Shrabony Knitwear Ltd.

17th November, 2016

Observations

High stress levels in columns (Main Production Building)

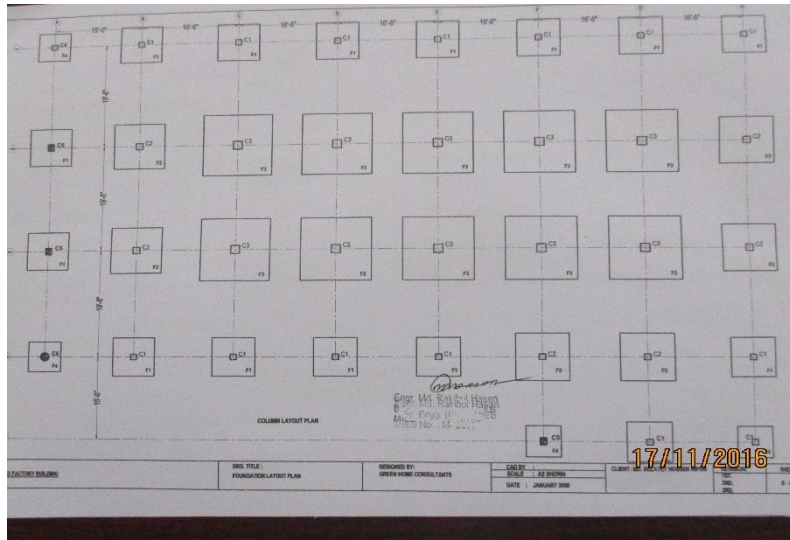
Cursory calculations indicate that the working stress in these internal columns are in excess of normal design limits.

Factory Engineer to perform a Detail Engineering Assessment (see attached scope) and concrete tests to prove adequacy of column sizes

Item No.	Observation	Recommended Action Plan	Recommended Timeline
1	High stress levels in columns (Main Production Building)	Building Engineer to review design, loads and column stresses in all columns for Main Production Building.	Immediate - Now
2	High stress levels in columns (Main Production Building)	Verify in-situ concrete stresses by 100mm dia. cores from 4 min. columns in the building.	Immediate - Now
3	High stress levels in columns (Main Production Building)	A Detail Engineering Assessment of Main Production Building to be commenced (see attached Scope).	Immediate - Now
4	High stress levels in columns (Main Production Building)	Detail Engineering Assessment to be completed	6-weeks
5	High stress levels in columns (Main Production Building)	Produce and actively manage a loading plan for all floor plates within the Building	6-weeks
6	High stress levels in columns (Main Production Building)	Actions identified in the Detail Engineering Assessment to be implemented.	6-months

As- Built Drawings not available

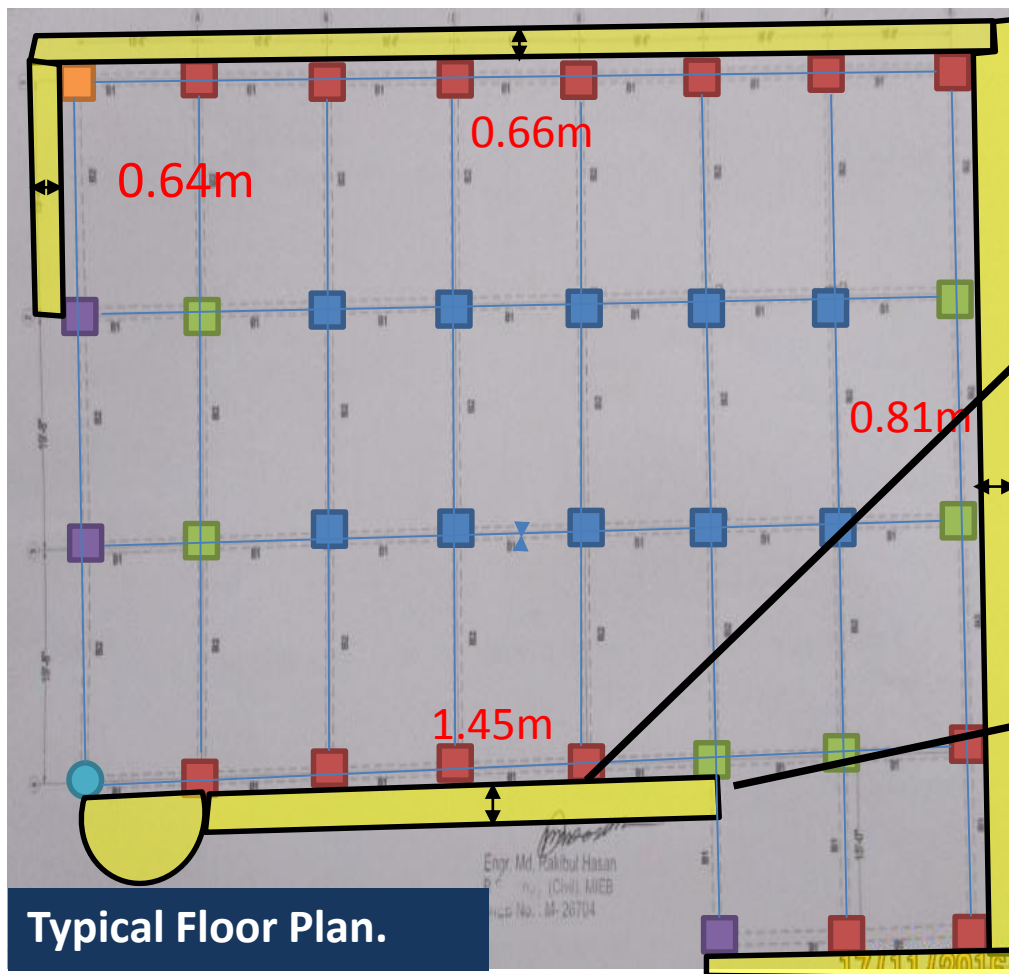
Structural drawings were available for Main production building only, but architectural drawings were not available

No detail drawings (As built structural) were found for other structures during inspection.

Cracks on masonry wall of cantilevered portion at first floor

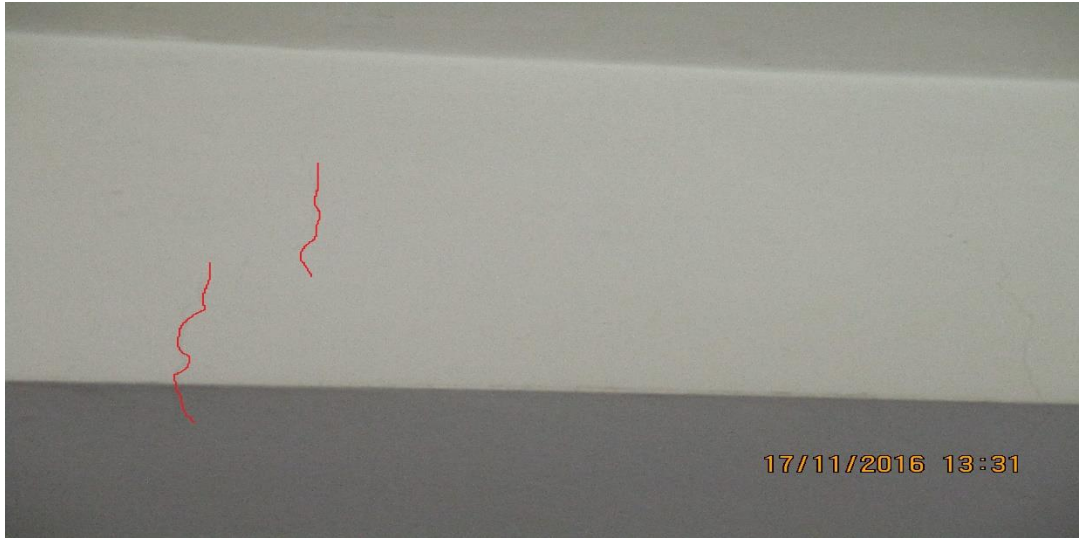
Cantilever portions were observed in Main Production Building

Cracks were observed during inspection at 1st floor of front cantilever portion.

Item No.	Observation	Recommended Action Plan	Recommended Timeline
8	Cracks on masonry wall of cantilevered portion at first floor	Building Engineer to verify reasons behind cracking and check if the deflection is within the limit.	6-weeks
9	Cracks on masonry wall of cantilevered portion at first floor	Propose any remedial measures required.	6-weeks
10	Cracks on masonry wall of cantilevered portion at first floor	Produce and actively manage a loading plan for all cantilever portions within the Building.	6-weeks
11	Cracks on masonry wall of cantilevered portion at first floor	Implement any remedial measures suggested by the engineer.	6-months
12	Cracks on masonry wall of cantilevered portion at first floor	Continue to implement the load management plan	6-months
13	As- Built Drawings not available	Comprehensive As-Built drawings are to be produced for all buildings.	6-weeks
14	Hairline cracking on beams at Main production building	Sections of plaster finish to beams and slab to be removed to investigate if cracks penetrate the building structure.	6-weeks
